RE: Master Drainage Report for Westpoint 40
Drainage Master Plan
Stamp Date: 10/10/17
Hydrology File: K09D041

Based upon the information provided in your submittal received 11/09/17, the Drainage Master Plan **is not** approved for Work Order. The following comments need to be addressed for approval of the above referenced project:

Re: Master Drainage Report for Westpoint 40 (Avalon Subdivision Unit 5)
Comment Response Letter
DRB Case No. 1009438, Hydrology File No. K09D041

DRAWN BY:	DB	DATE:	08/14/17
CHECKED BY:	VCS	PROJECT NO.	20180059
		SHEET NO.	1 OF 2

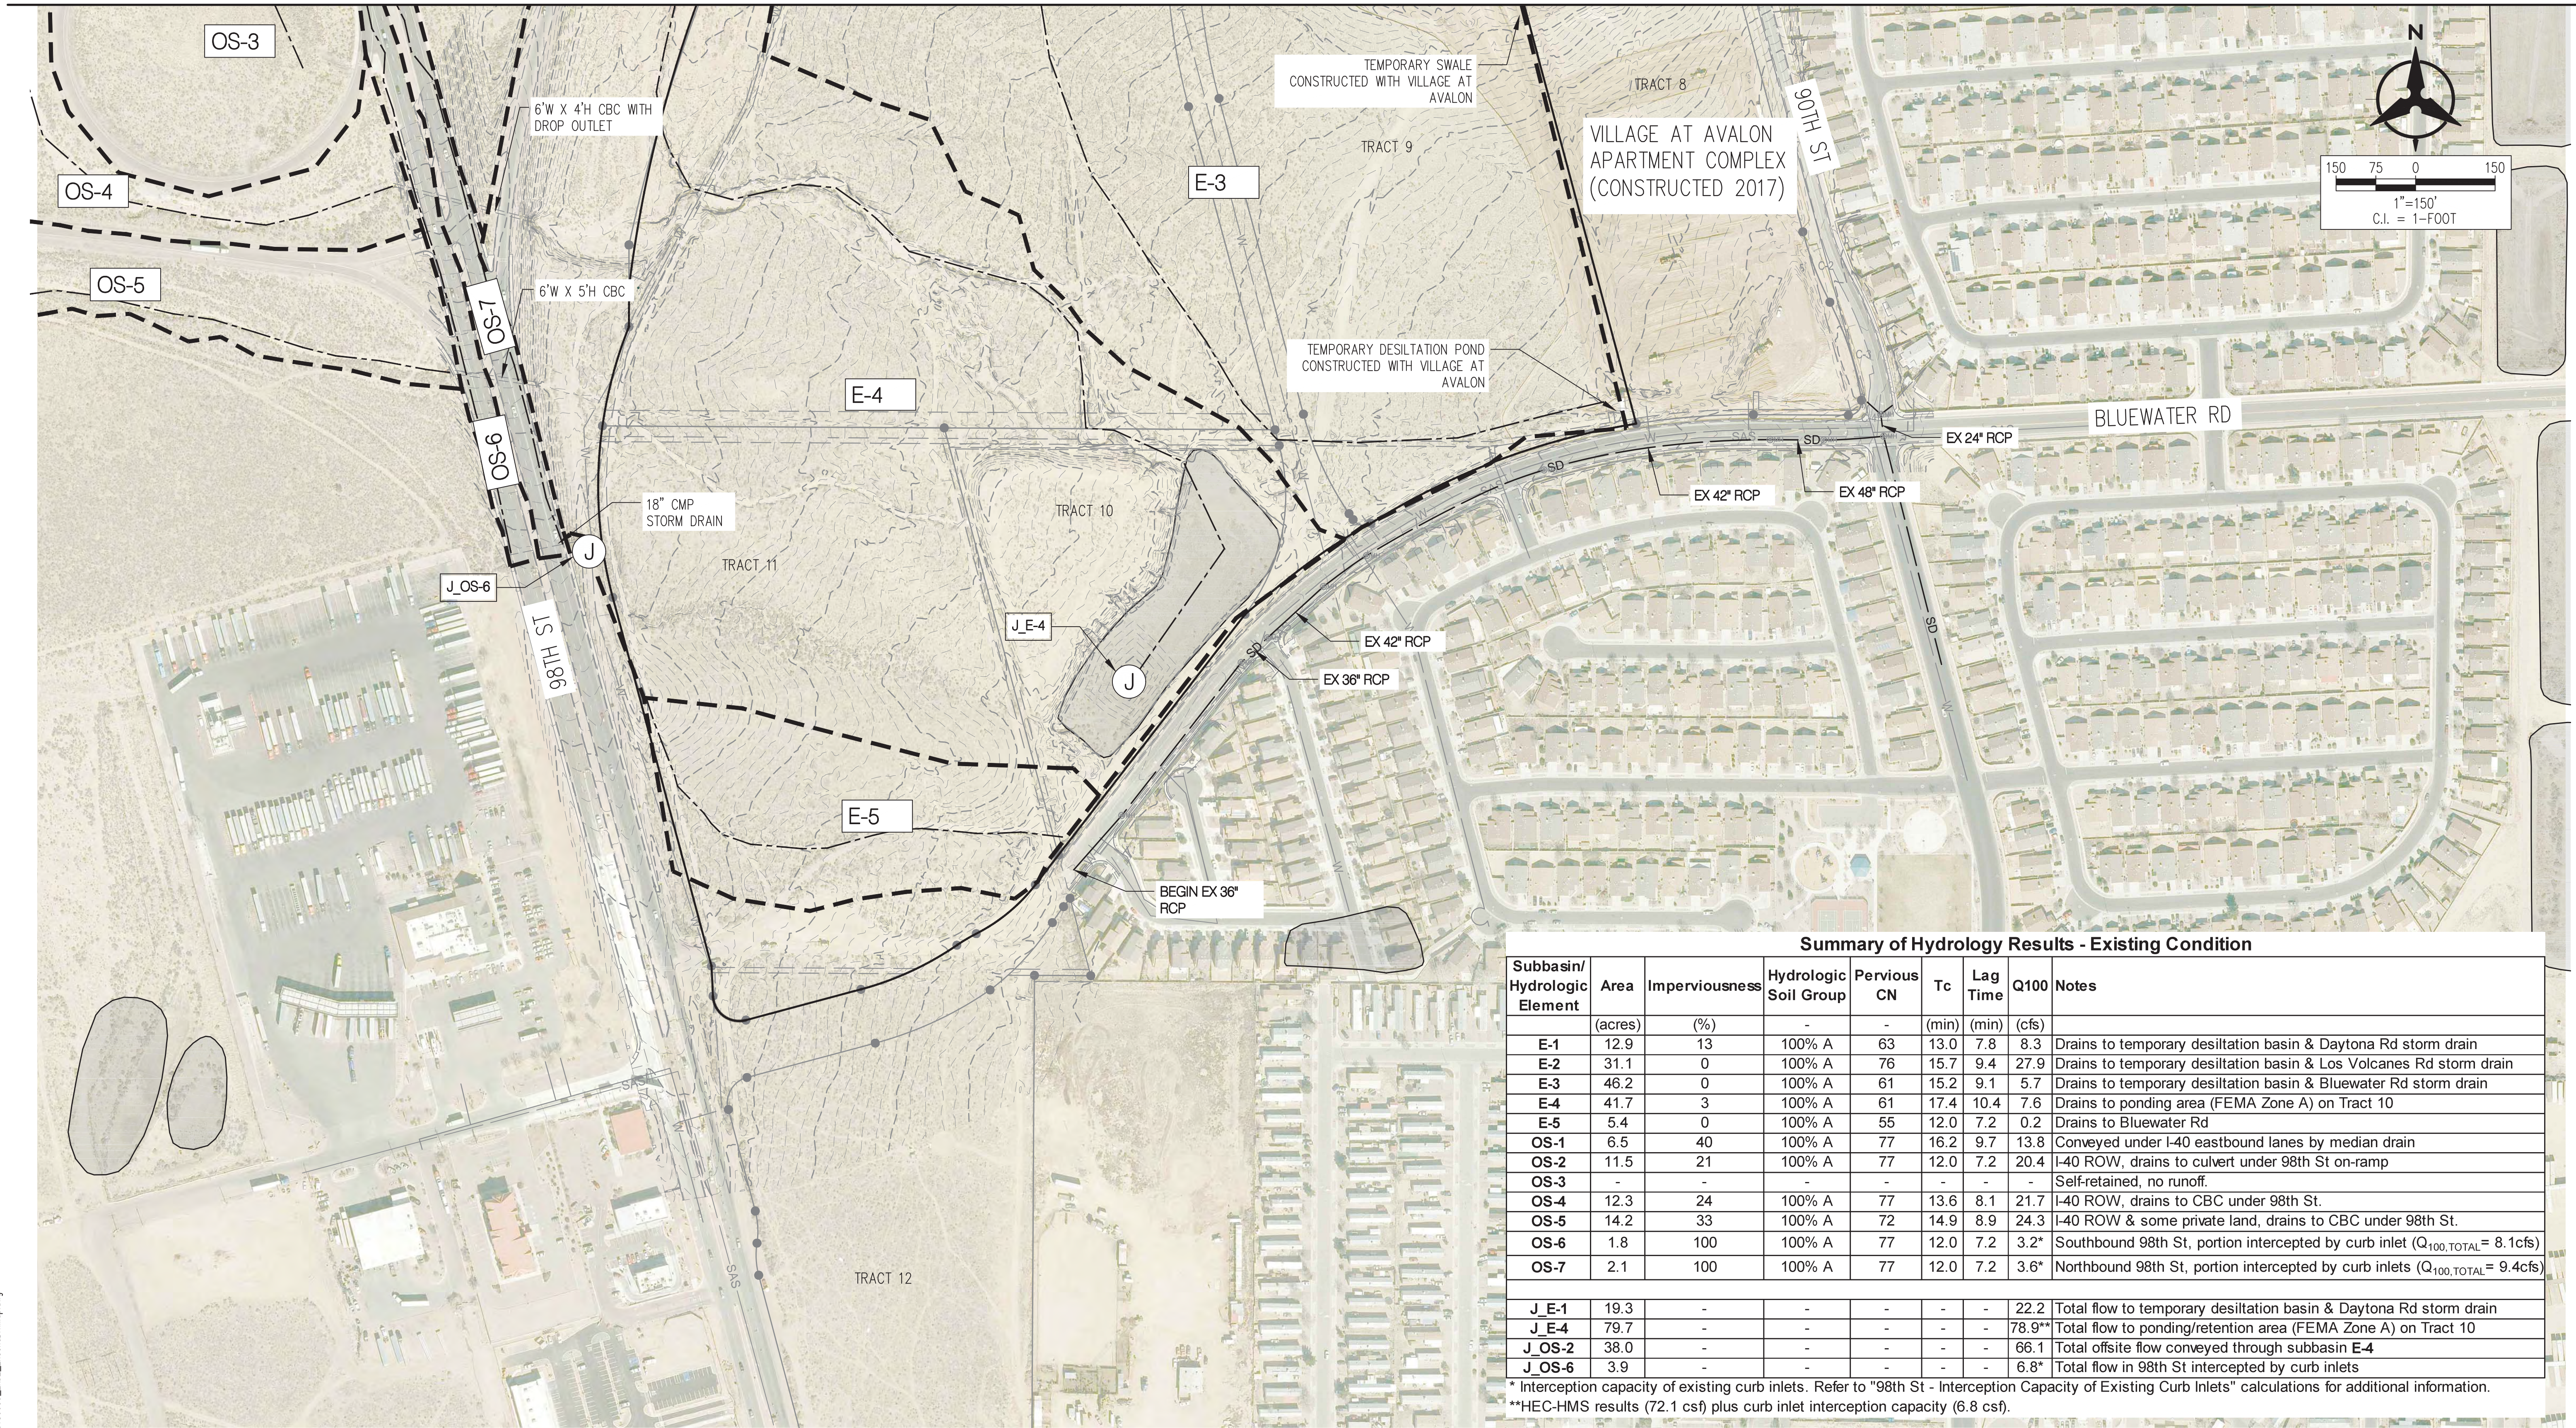
3. On Exhibit 2 - Sheet 2 of 2, please label the existing storm sewer on 90th St. just south of Blue Water as an existing 54" RCP.
4. On Exhibit 3 – Sheet 2 of 4, please add a note that a spillway will be provide from the detention pond to Daytona Rd within the proposed drainage easement. Also add this wordage about the spillway in the drainage report Section V. Developed Conditions B.2 Option A.

DRAWN BY: DB DATE: 09/20/2017
CHECKED BY: VCS PROJECT NO. 20180059 SHEET NO. 3 OF 4

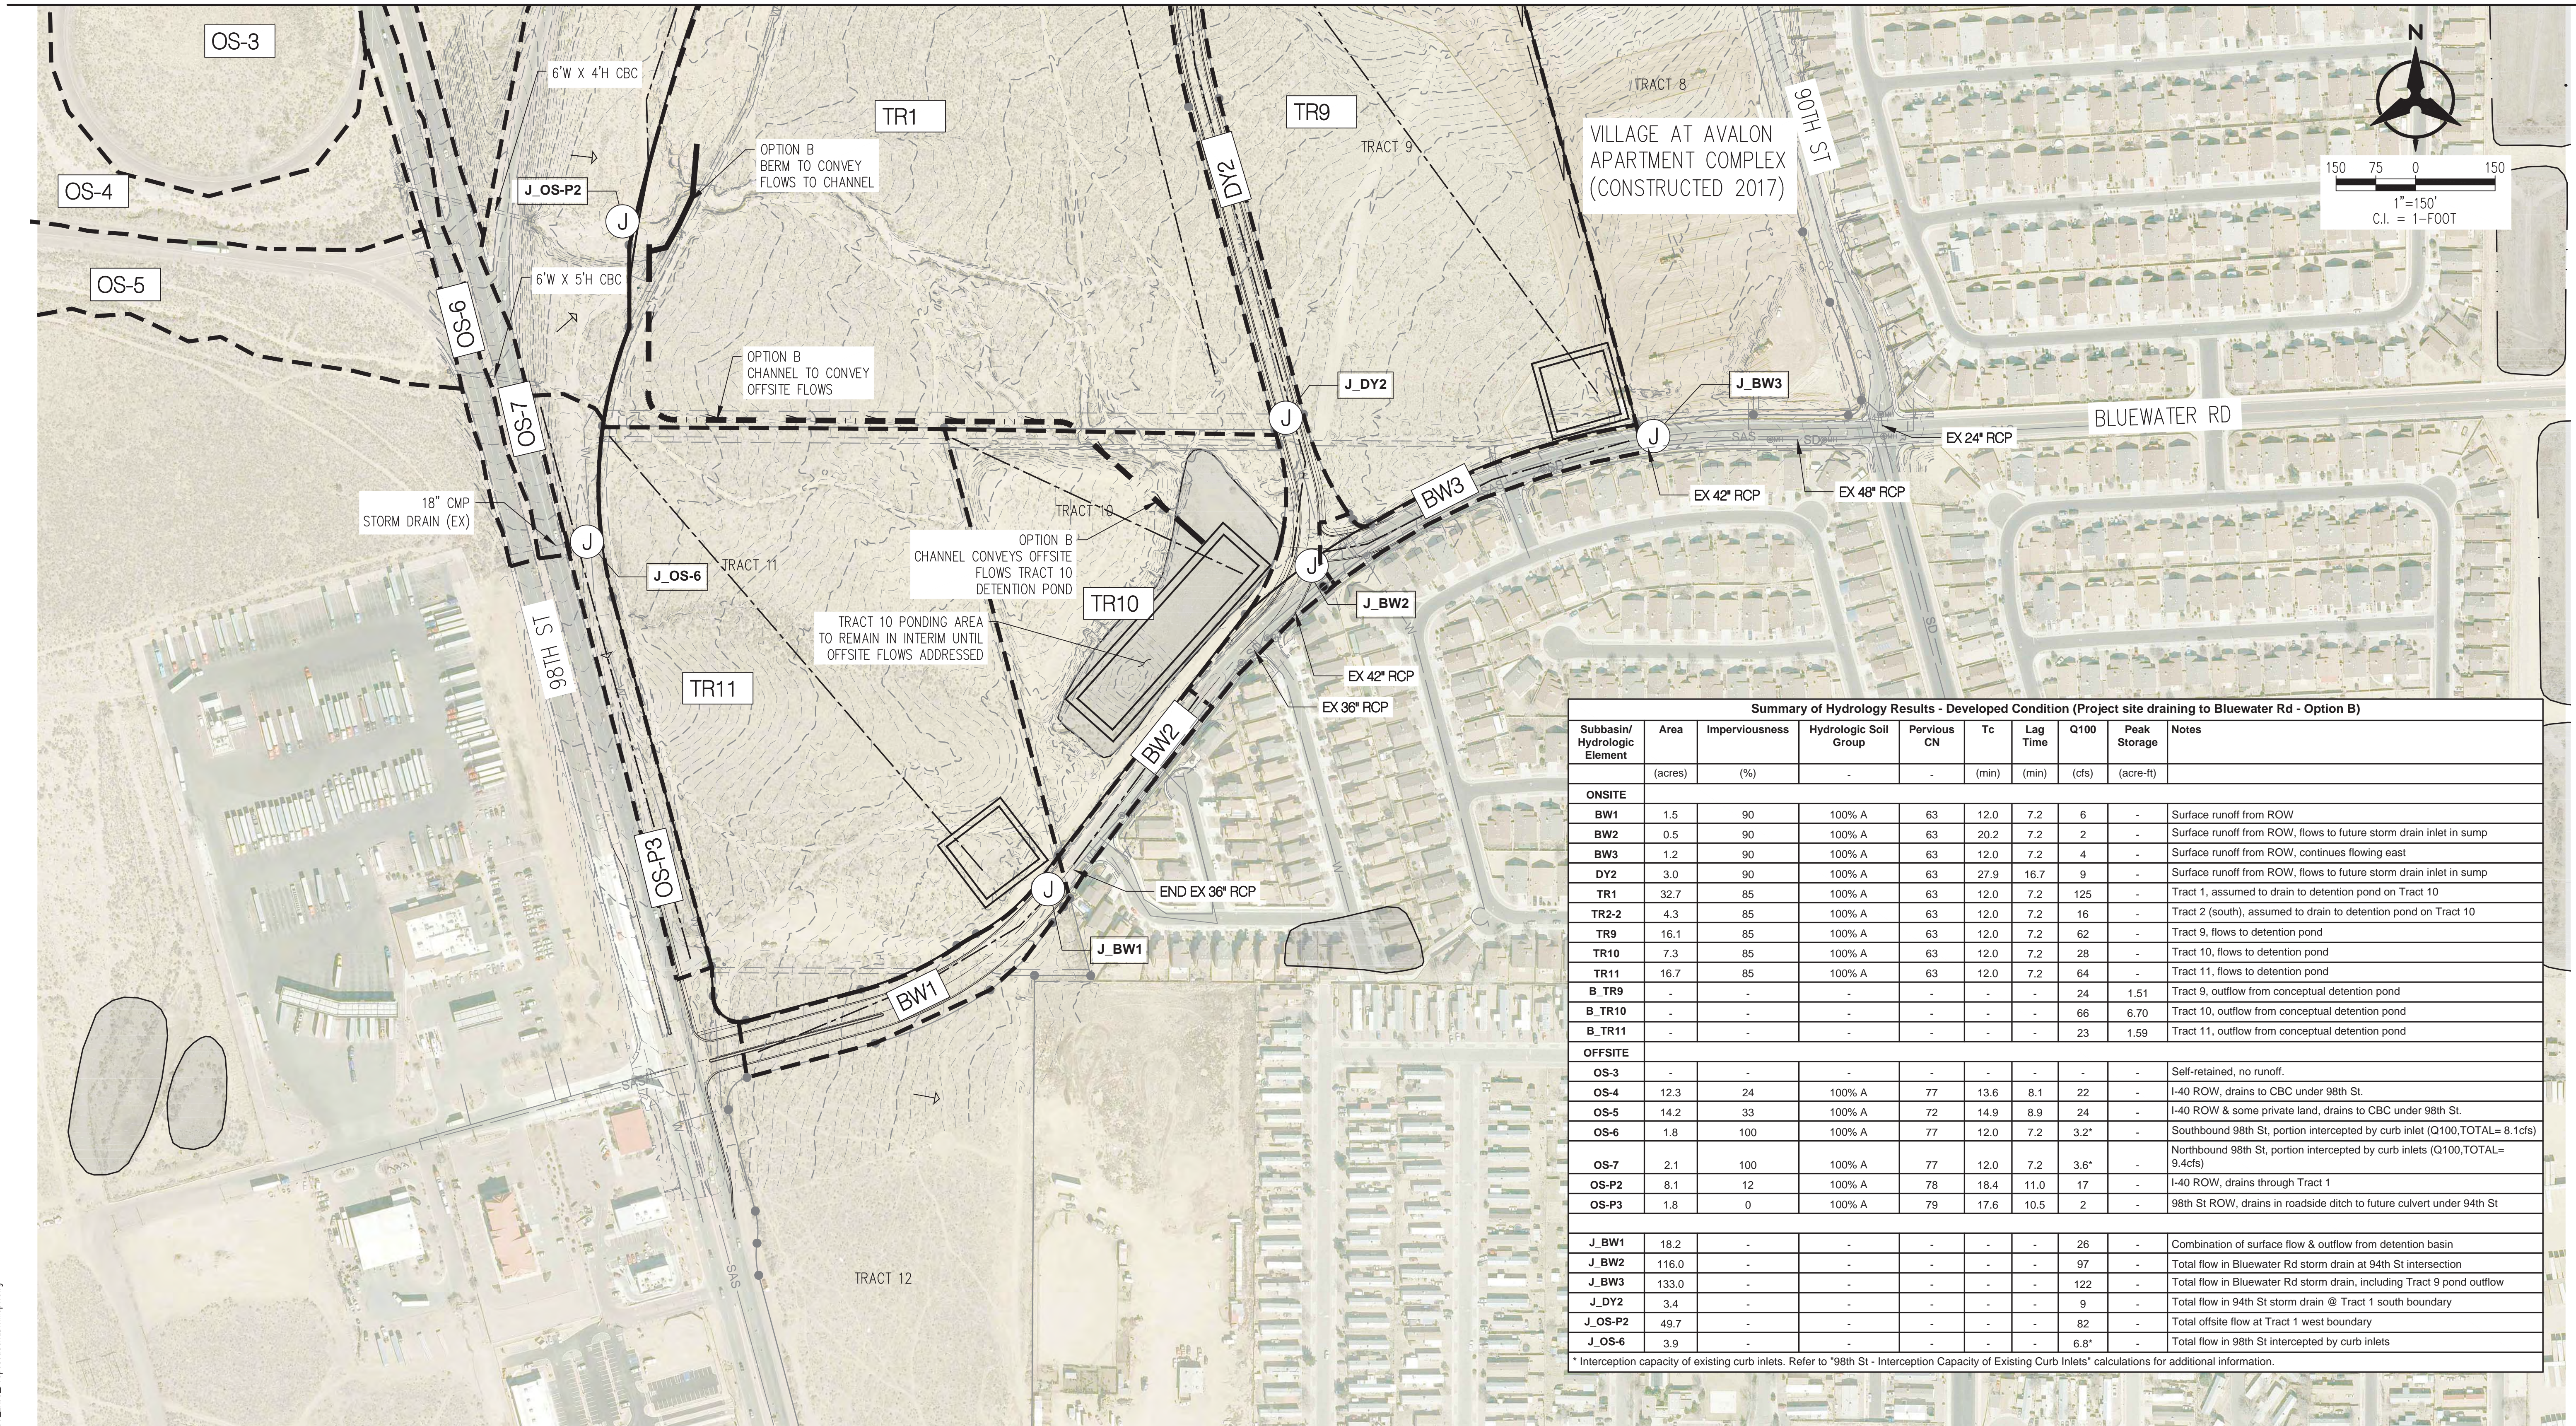
5. On Exhibit 3 – Sheet 3 of 4, please add a drainage easement on the entire dike since it is carrying public storm water.
6. On Exhibit 3 – Sheet 4 of 4, please add a drainage easement on the entire dike since it is carrying public storm water.
